March 28, 2014
Subject: **Augusta Phase 2**
State Project No: 020118.20
Amendment No. 2

Make the following change to the Bid Documents:

8
A603

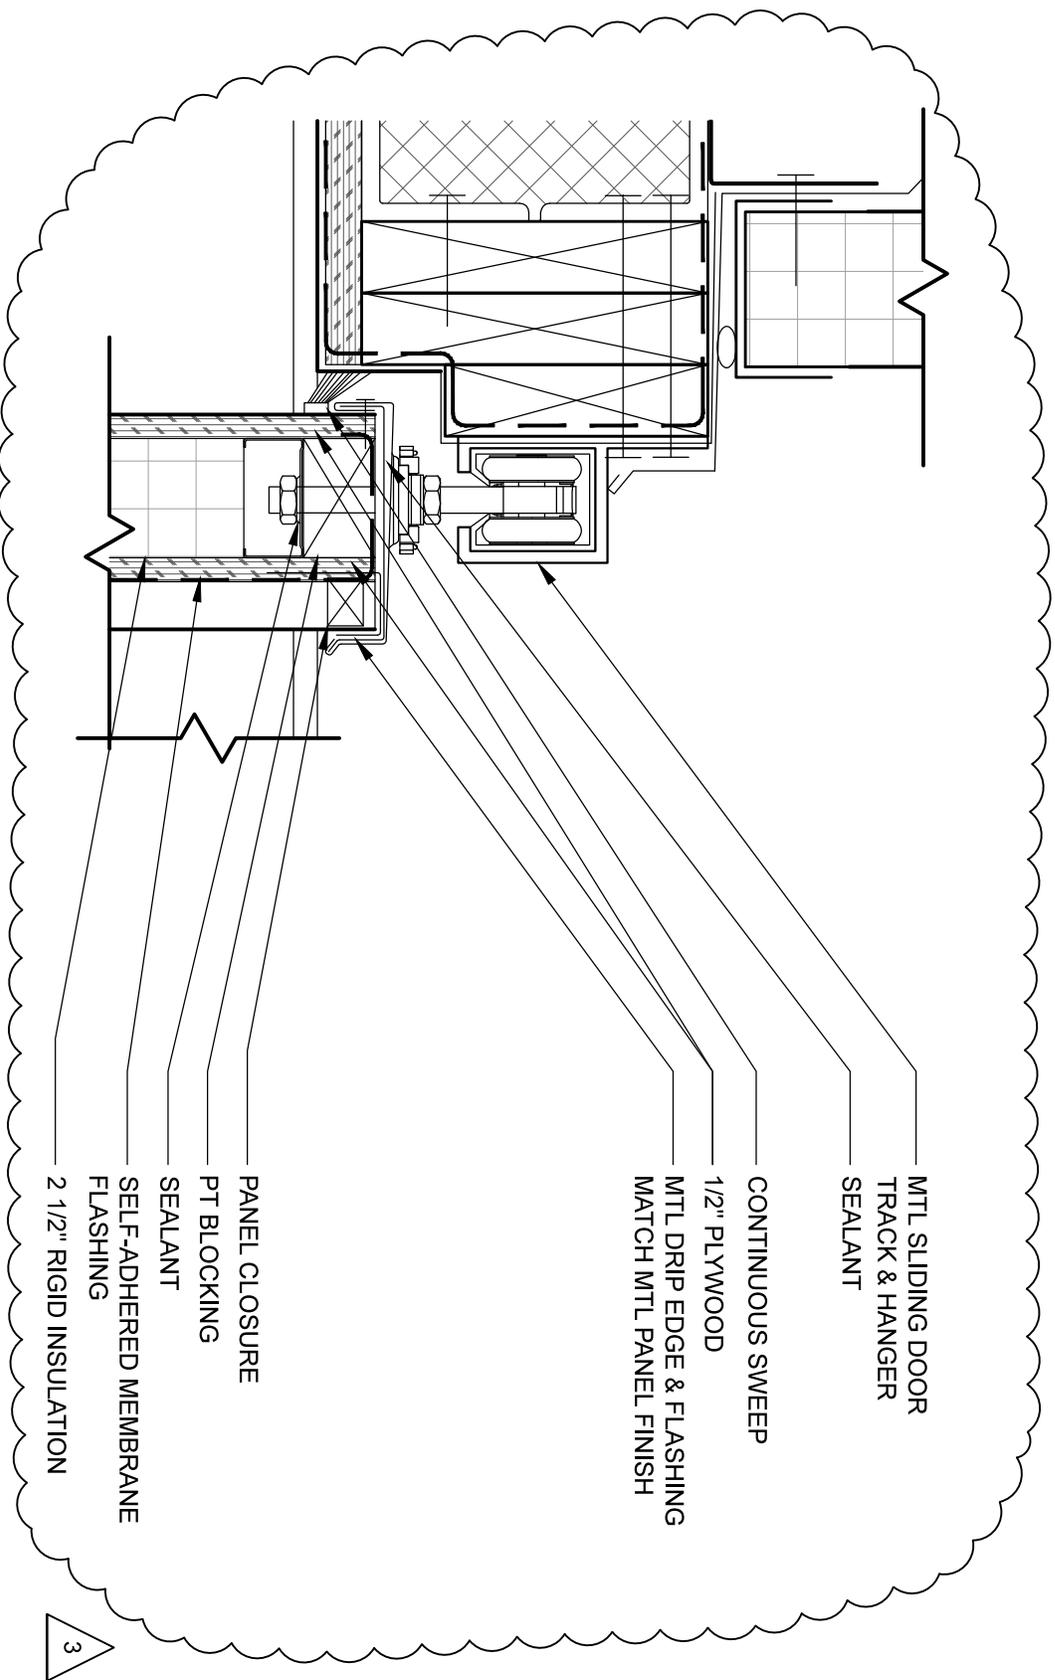
On plan sheet A603 **ADD** Drawing 8 Door Head Detail per SKA-34 DOOR HEAD DETAIL.

9
 A603
Sill Detail
 SCALE: 3" = 1'-0"

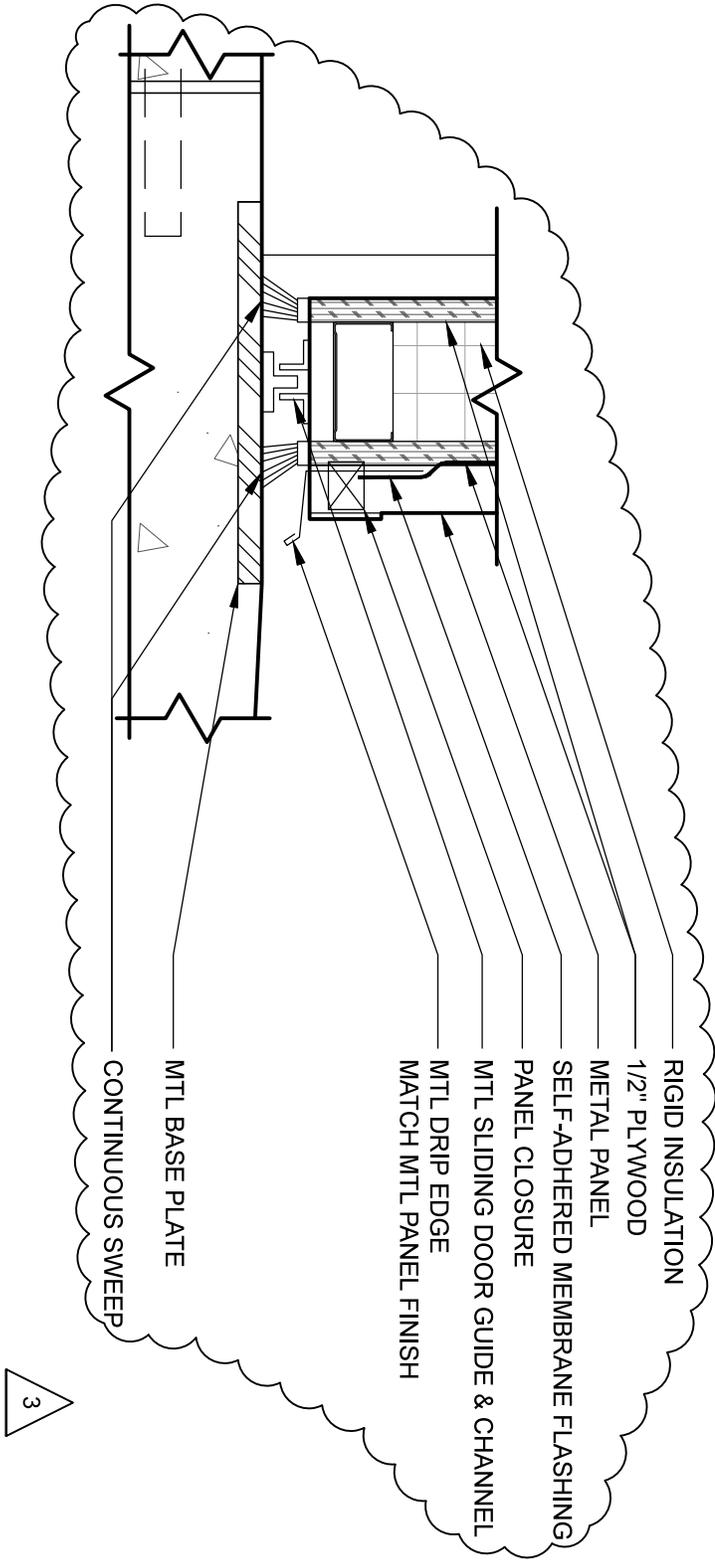
On plan sheet A603 **ADD** Drawing 9 Door Sill Detail per SKA-35 DOOR SILL DETAIL.

10
Jamb Detail
 A603 SCALE: 3" = 1'-0"

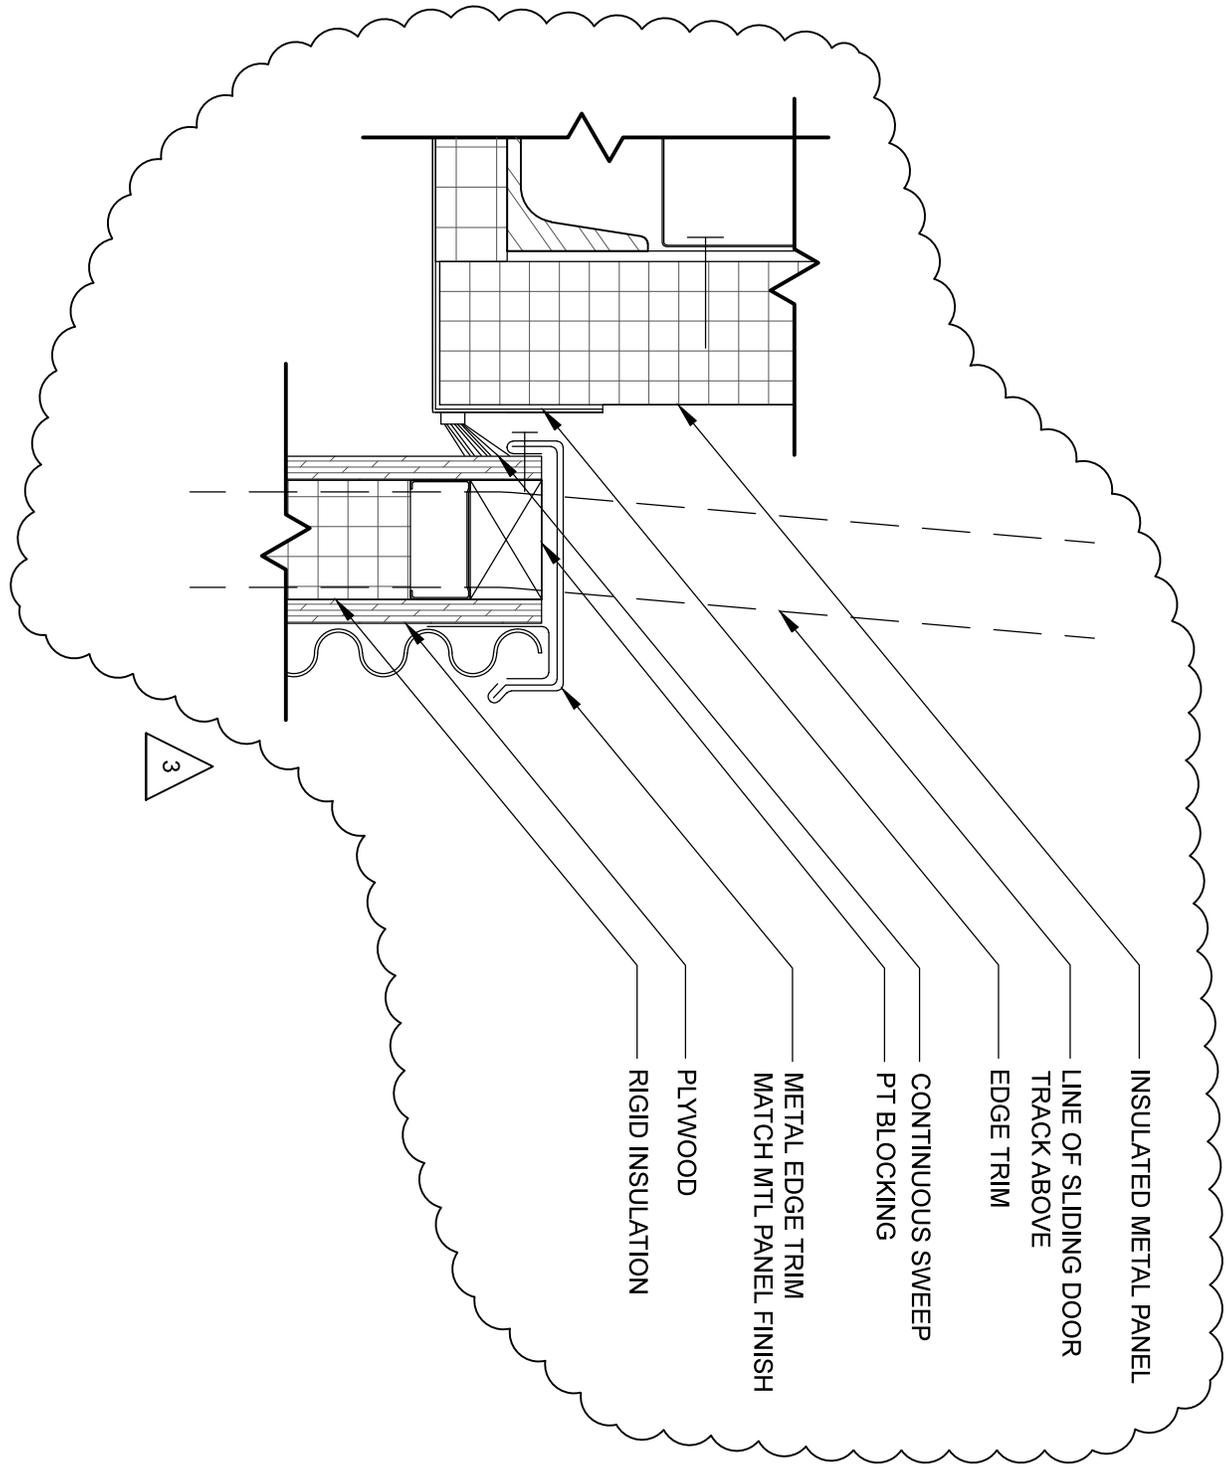
On plan sheet A603 **ADD** Drawing 10 Door Jamb Detail per SKA-36 DOOR JAMB DETAIL.
